THREE MILE ISLAND NUCLEAR STATION
UNIT NO. 1 EMERGENCY PLANNING IMPLEMENTING PROCEDURE 1004.8
CALLOUT OF ONSITE AND OFFSITE DUTY ROSTER PERSONNEL

Three Mile Island Nuclear Station Temporary Change Notice (TCN)

12. TCN No. 1-83-0217 (From TCN Log Index)

ITEM: TCN
EPIP 1004.7
OFFSITE/ONSITE DOSE PROTECTION

ATTACHMENT VIII

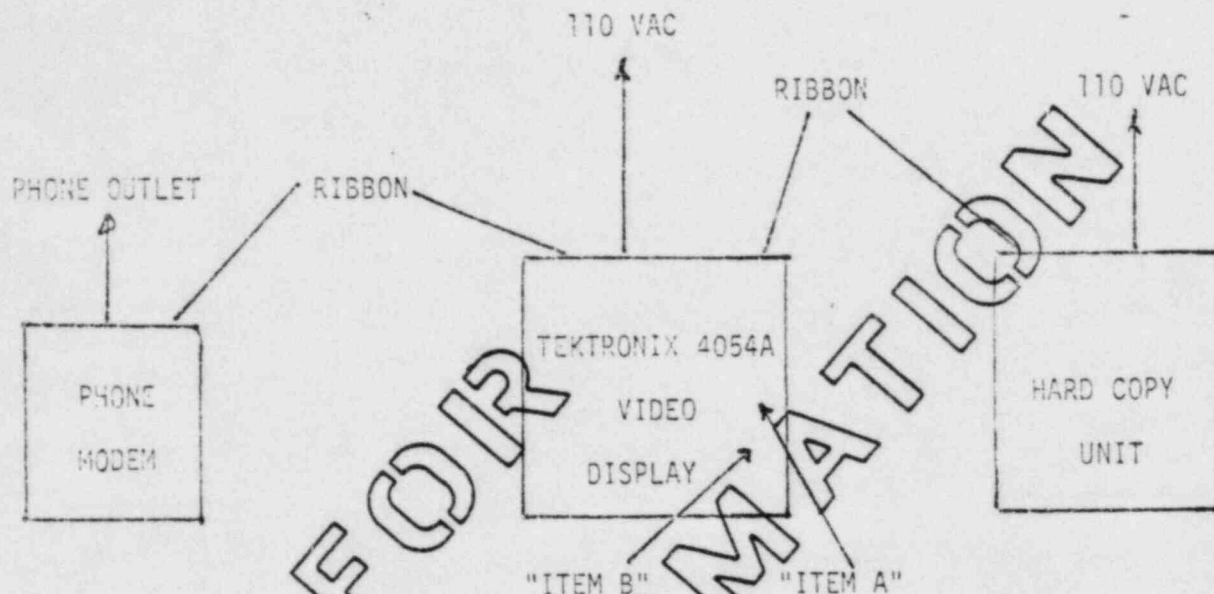
1. Replace present attachment VII with the "TCS Air Sample Nomograph".
2. Add to attachment VIII the material provided in sequential order. -

9. For operation of the Tektronix 4054A minicomputer. Ensure all components are energized and connected as shown below:

10. Insert cassette labeled "TMI Unit 1 EP1an" Rev. 3.0 into the unit (see schematic - Item A).
11. Depress the "Auto Load" button (See schematic - Item B) on the keyboard.
12. Begin program execution.
13. The EAC shall utilize Midas with the Acriso routine to project dose rates. The EAC shall use the semi-infinite model.
